In response to your applications dated May 18, 1979 (L-79-122 and L-79-124) as supplemented on May 29 and June 8, 1979, the Commission has issued the enclosed Amendment Nos. 49 and 41 to Facility Operating License Nos. DPR-31 and DPR-41 for the Turkey Point Nuclear Generating Plant, Unit Nos. 3 and 4.

The amendments consist of changes in the Technical Specifications that approve the operation of Turkey Point Unit Nos. 3 and 4 with a peaking factor of 2.10, assuming that no more than 22% of the steam generator tubes are plugged. In addition, Amendment No. 41 to License No. DPR-41 permits continued operation of Turkey Point Unit 4 for six equivalent months of operation from June 1, 1979. The application (L-79-122) requested ten equivalent months of operation; however, we preferred not to predict the steam generator performance for longer than six months at a time. We have discussed this with your staff and they have accepted this judgment. Also, for our administrative convenience, we are reissuing new pages 3 through 6 for Facility License No. DPR-41. Paragraph 3.D.1 is amended to include the new operating period and is expanded to be consistent with the requirements for Unit 3.

AT

Figure 3.2-3a Amendment No. 49, Unit 3
Amendment No. 41, Unit 4

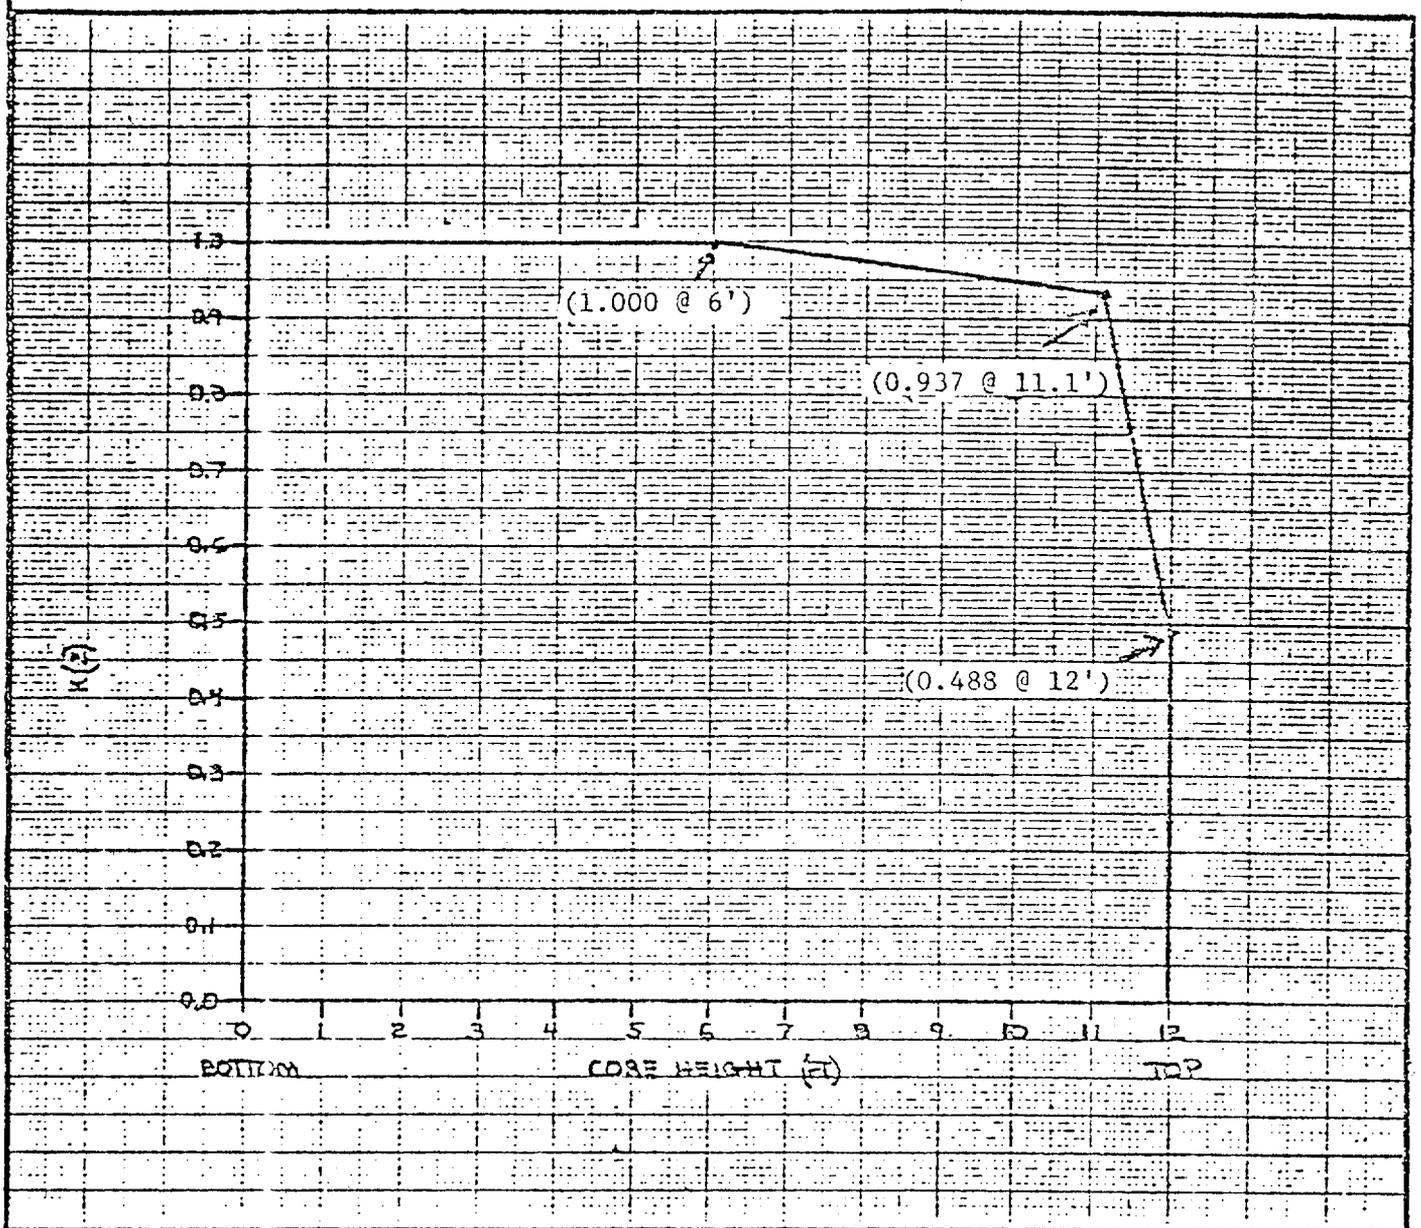
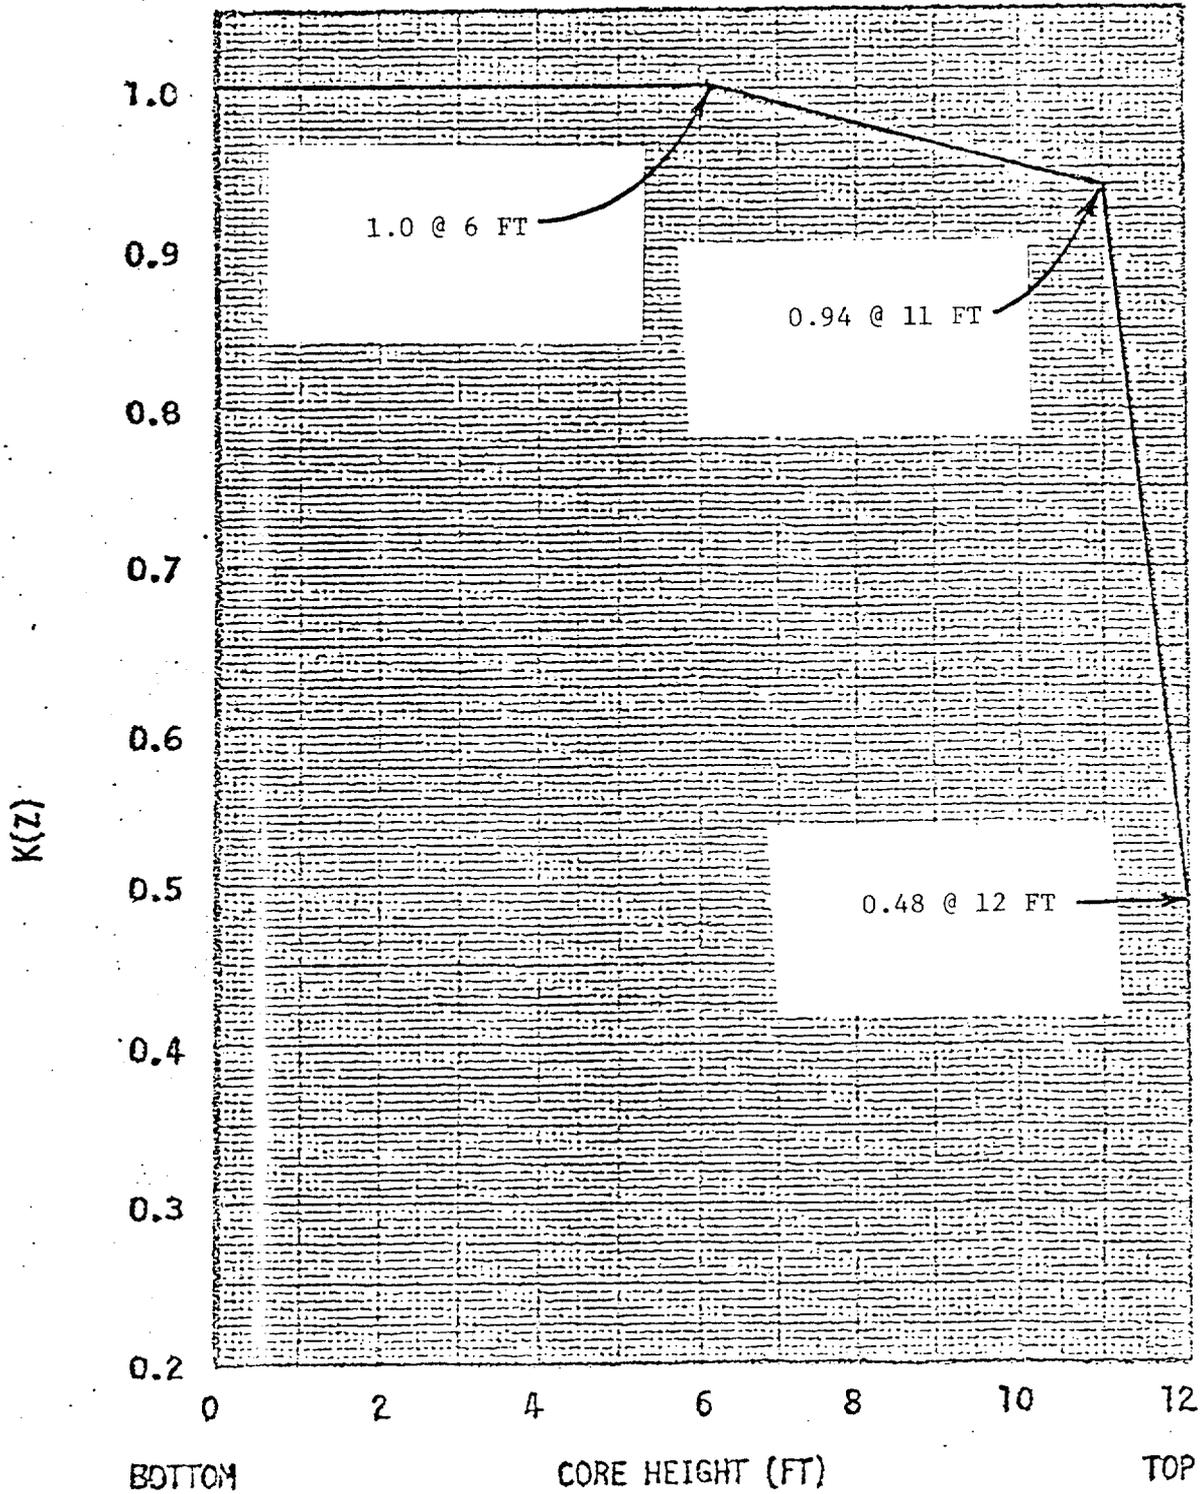
- (2) With steam generator tube plugging ≤ 22%, the hot channel factors (defined in the basis) must meet the following limits at all times except during low power physics tests:

Where P is the fraction of rated power at which the core is operating; K(Z) is the function given in either Figure 3.2-3 or 3.2-3a; Z is the core height location of F_q .

$$F_q(Z) \leq (2.10/P) \times K(Z), \text{ for } P > .5$$

$$F_q(Z) \leq (4.20) \times K(Z), \text{ for } P \leq .5$$

HOT CHANNEL FACTOR - NORMALIZED
OPERATING ENVELOPE (for
steam generator tube plugging
22% and $F_q = 2.10$)

FIGURE 3.2-3b

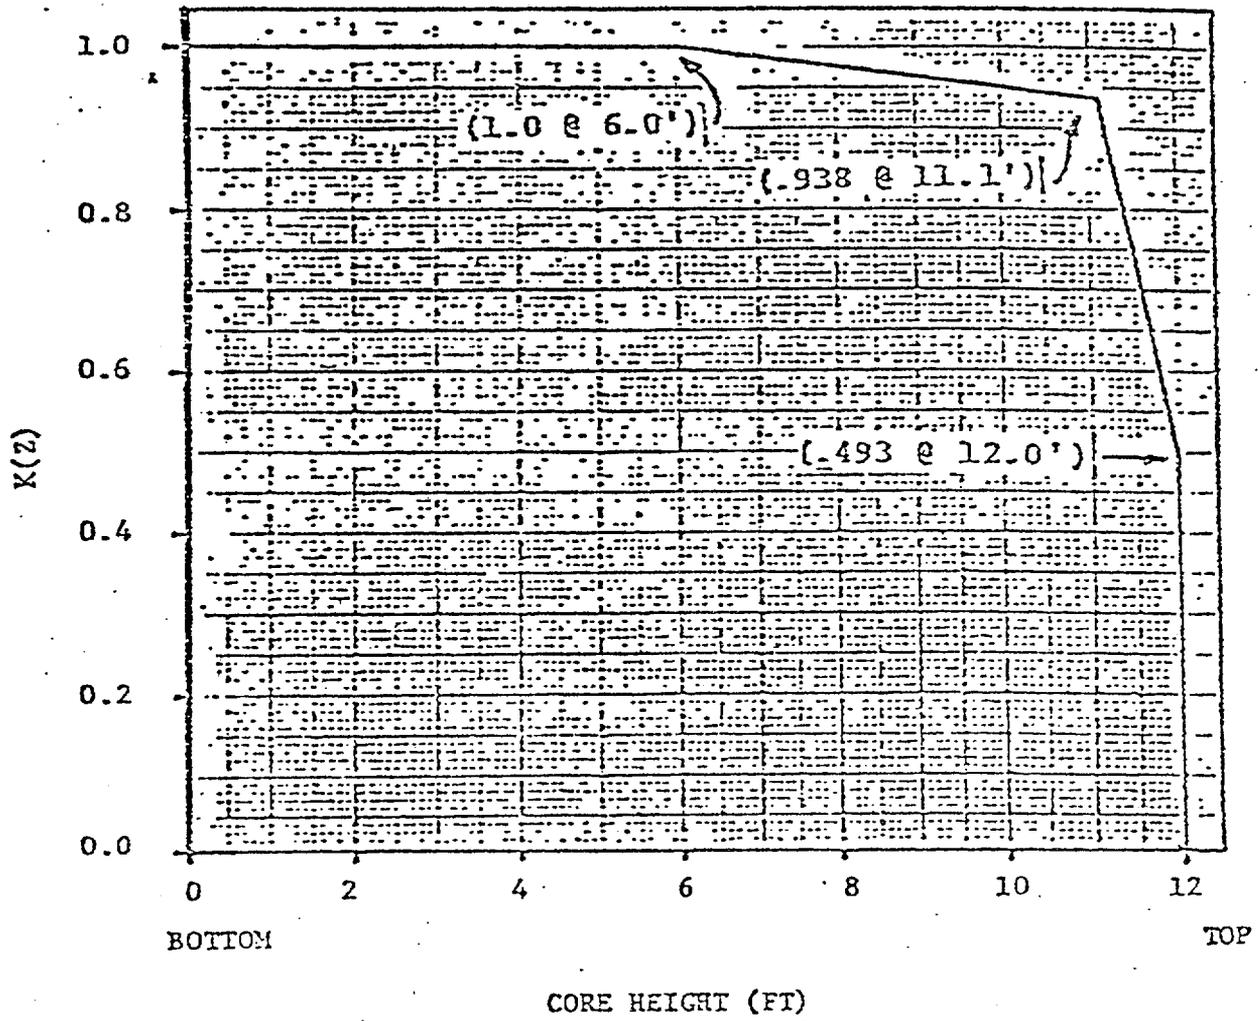
- (1) With steam generator tube plugging >22% and ≤25%, the hot channel factors (defined in the basis) must meet the following limits at all times except during low power physics tests:

Where P is the fraction of rated power at which the core is operating; K(Z) is the function given in Figure 3.2-3b; Z is the core height location of F_q .

$$F_q(Z) \leq (2.03/P) \times K(Z), \text{ for } P > .5$$

$$F_q(Z) \leq (4.06) \times K(Z), \text{ for } P \leq .5$$

HOT CHANNEL FACTOR-NORMALIZED
 OPERATING ENVELOPE (FOR STEAM
 GENERATOR TUBE PLUGGING $\leq 25\%$ and $F_q = 2.03$)
